St Albans skate park revamp	– Submissions Jan/Feb 2020	
ID	Do you support extension & design?	Is there anything you think we should include, remove or change?	Any other comments?	Name
32315	Not indicated		Thank you for the opportunity to submit on the plans to extend the Skate Park at St Albans Park. Based on information gathered from local residents by SARA Committee Members over the past month and from the St Albans Community Conversations held by the CCC in 2012 and SARA's survey of the community in 2013 we have the following to convey.	St Albans Residen Association
			St Albans lacks youth orientated spaces and there is a need for a safe place for teenagers to be without supervision. Our youth need gathering points and the skatepark can be this. With a pump track in Shirley and one being built for community use at St Francis of Assisi School it is felt that the focus of this project should be on the youth rather than younger riders. In addition to this SARA would like to the CCC to think about the Bowling Club space for a youth orientated venue in the future.

St Albans skate park revamp - 2D plans

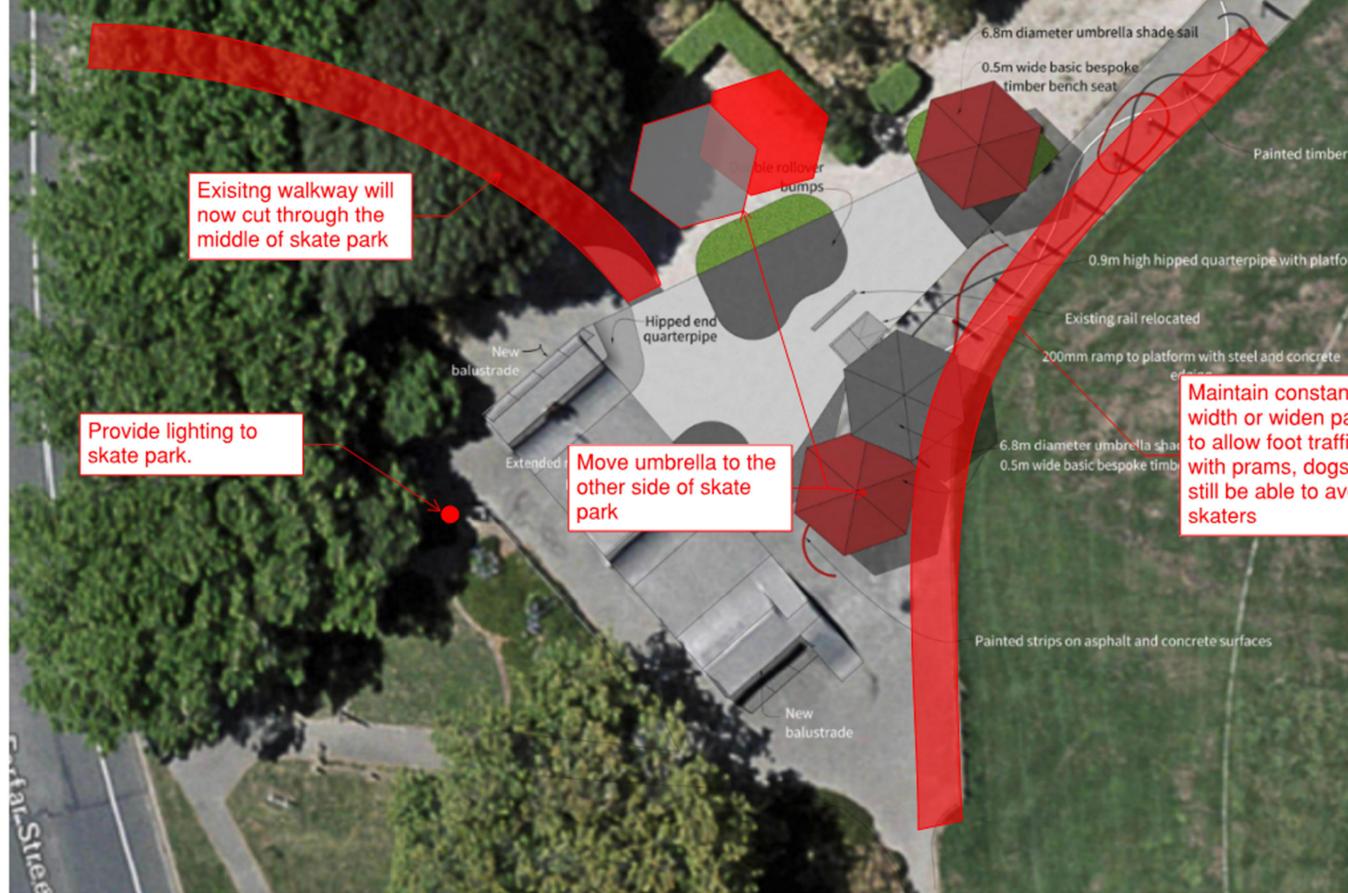
Maintain constant width or widen path to allow foot traffic with prams, dogs to still be able to avoid skaters
